**Correspondence Between  
Staff and Applicant  
Approval Letter**

RE: 18-DR-2017  
2nd St. Hub

**2<sup>nd</sup> Street HUB**  
3712 & 3720 N. Scottsdale Road  
S.W.C. Scottsdale Rd & 2<sup>nd</sup> Street  
Scottsdale, Arizona

**OPTION B REFUSE RELOCATION**

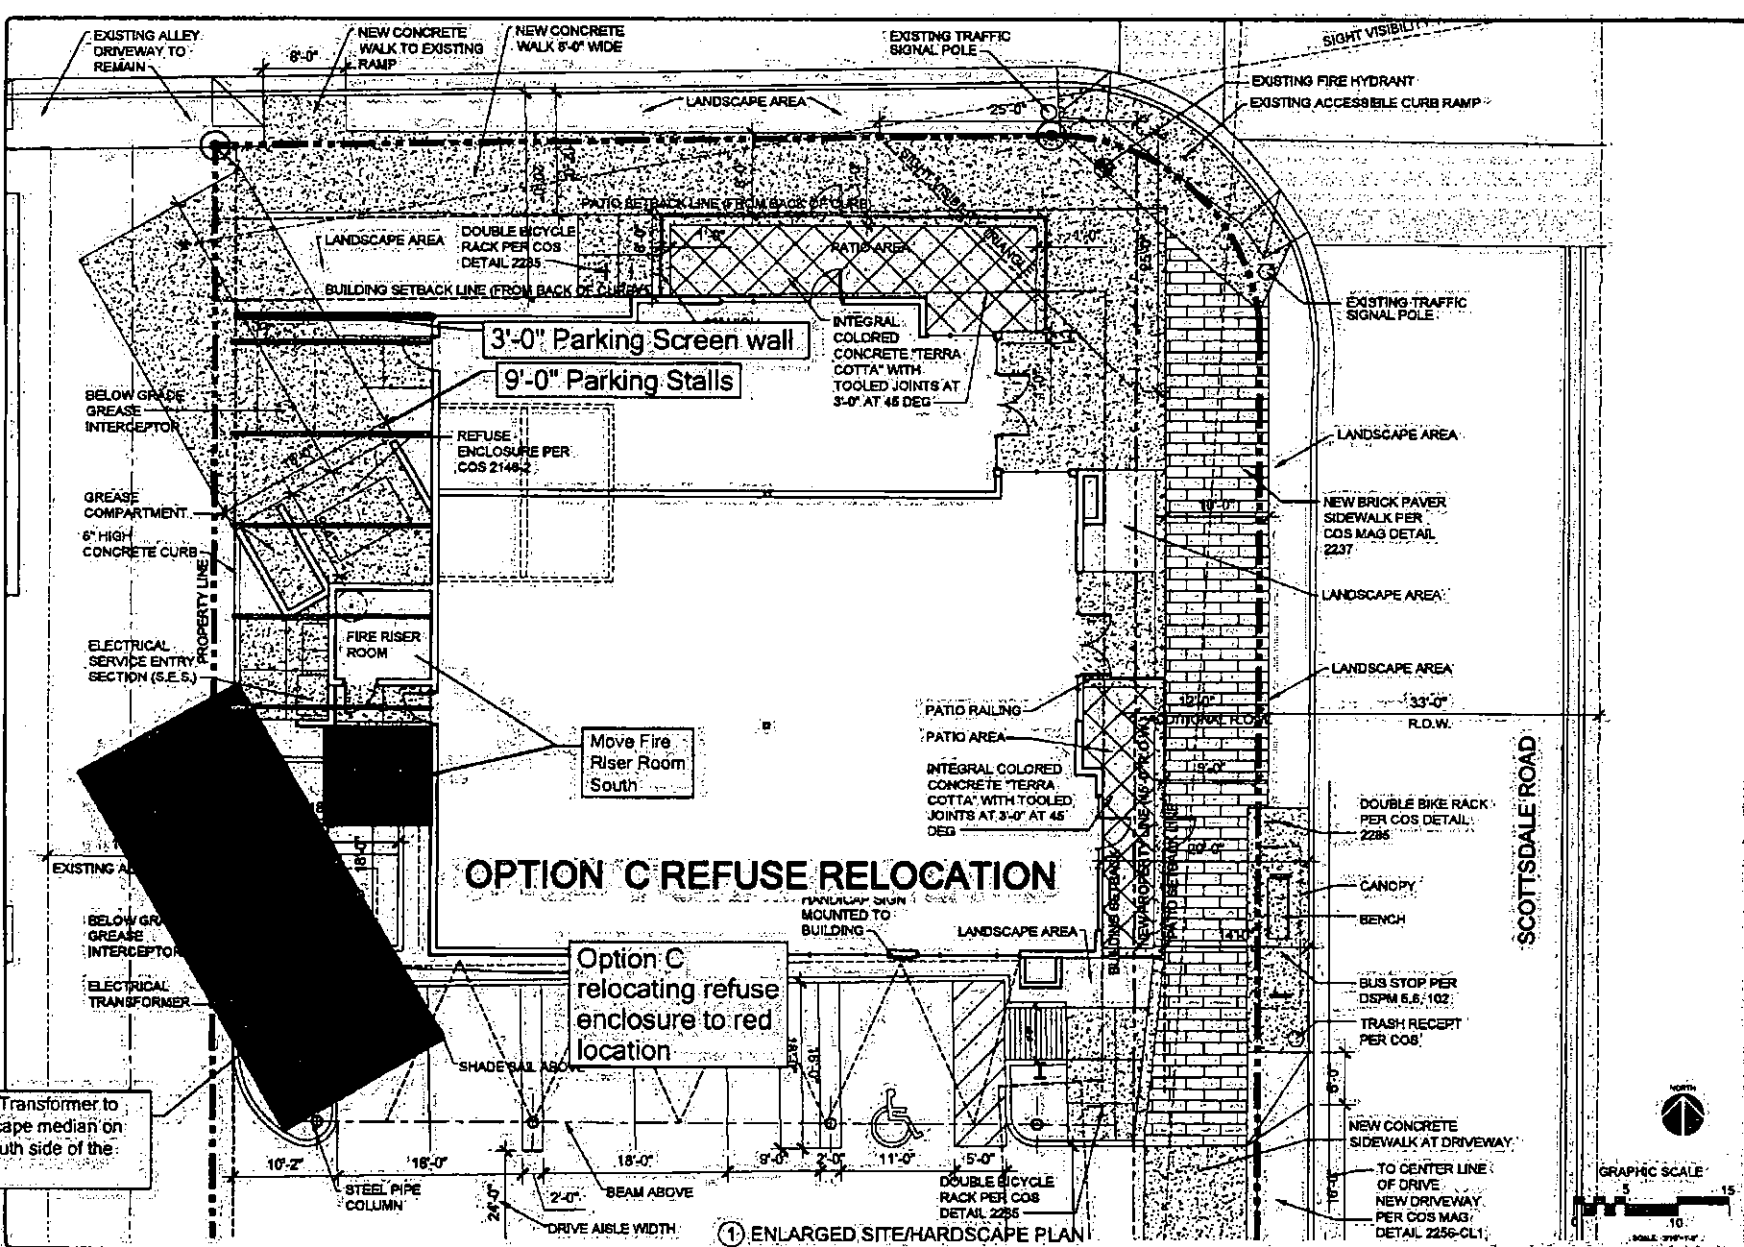
Option B relocating refuse enclosure to red location

business on the two lots. The shared refuse agreement shall be reviewed and approved by the City of Scottsdale Attorney's Office, and Solid Waste Director, or designee. Staff also provided Options B and C as alternatives; but, Option is the preferred solution.

# OPTION A REFUSE RELOCATION

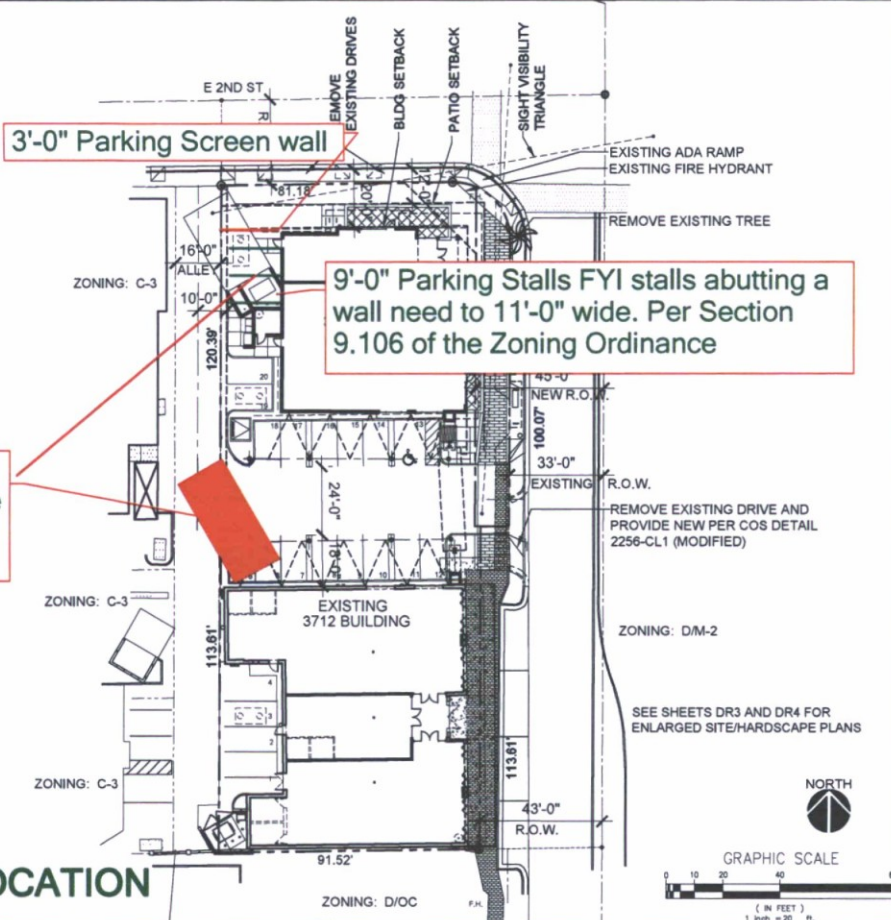
Due to the limited area and alley restrictions, staff proposes the owner provide the following alternative refuse solution, Option A: (Please refer to the markup included as Attachment A):

- a. Shift the proposed Lot 1 refuse enclosure to the northwest corner of the Lot 2, and reconfigure the Lot 1 where the refuse enclosure is proposed, to accommodate additional parking. This enclosure shall conform with COS MAG Detail 2146-2, with the screen wall raised so that the wall is one foot taller than the refuse compactor (Section 7.105.A.2. of the Zoning Ordinance).
- b. Limit the use of the refuse enclosure on the southwest corner of the south lot to non-restaurant refuse.
- c. Record a shared refuse agreement against the north and south lots, or combine the lots into one lot to allow the uses of the reduce number of refuse enclosures for both properties and the compactor and grease containment to be used by all restaurants and

Option A relocating refuse enclosure to red location

9. The north refuse enclosure has been changed per the request from staff.
10. The non-motorized public access easements have been shown on Sheet DR2 and will be a part of the plat process.

**OPTION B REFUSE RELOCATION**

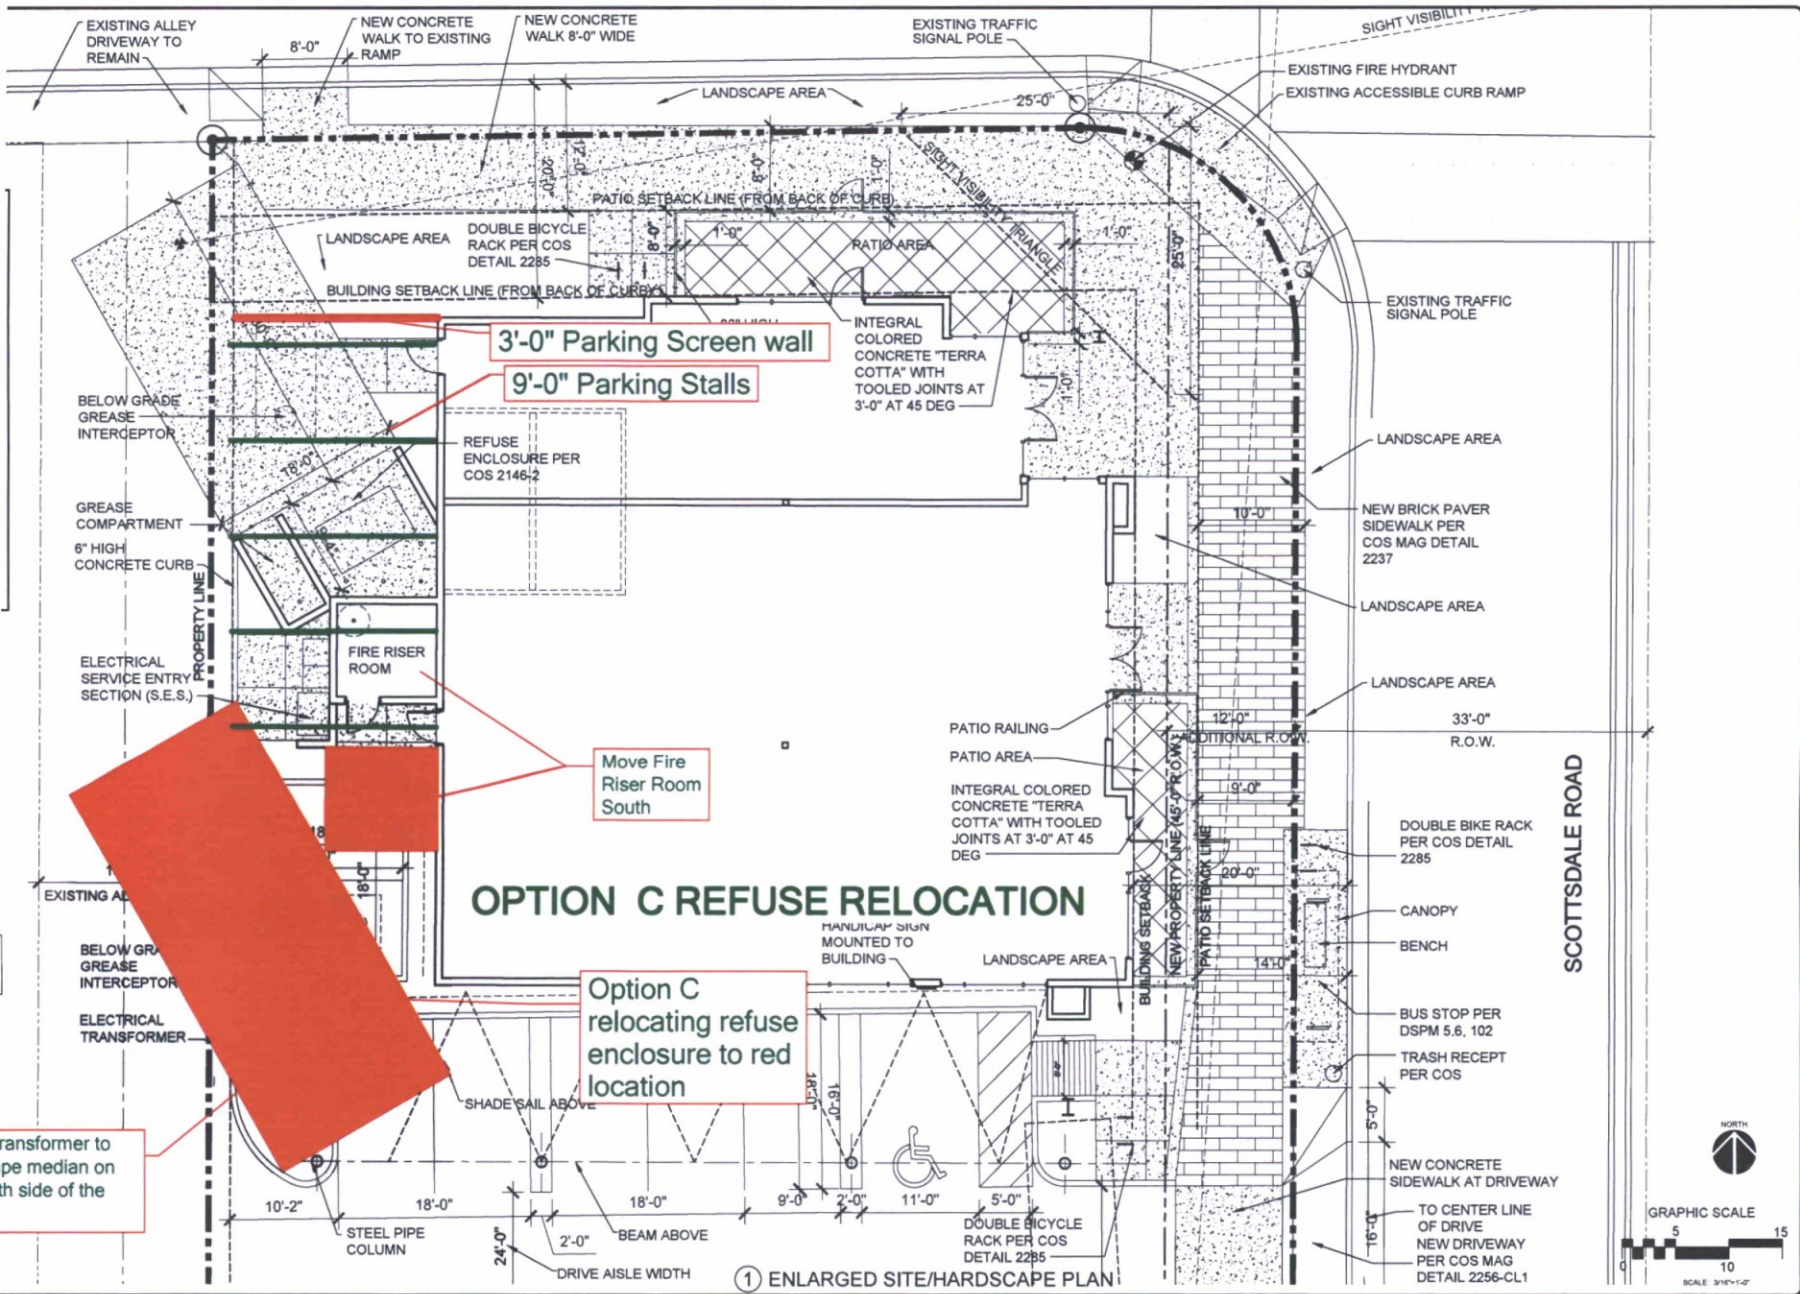
Option B relocating refuse enclosure to red location
